Access Compliance Report

Public Rights-of-Way

Intersection ID: 48949	Main Street: OLD_STONE_CROSSING_DR	Cross Street: DAVID_JENNINGS_AV	Location: SW
ADA ID: 18298A18B212	Ramp Type: BlendTrans1	Initial Pass/Fail: Fail	Overall Compliance: No
Severity Score: 8.75			
Codes/Mitigation Info/Possible Solution		Field Measurements/Component Compliance

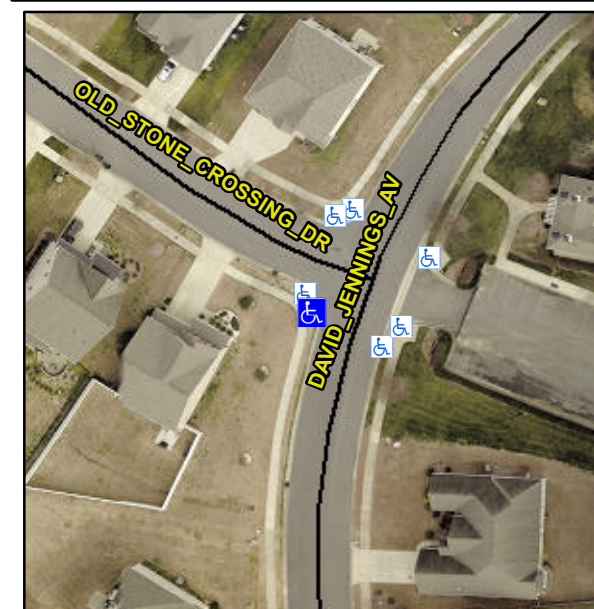
RT FL LIP 1.0

Not Found, R304.5.1

Remove & Replace Curb Ramp With Two New Directional Ramps or Equivalent.
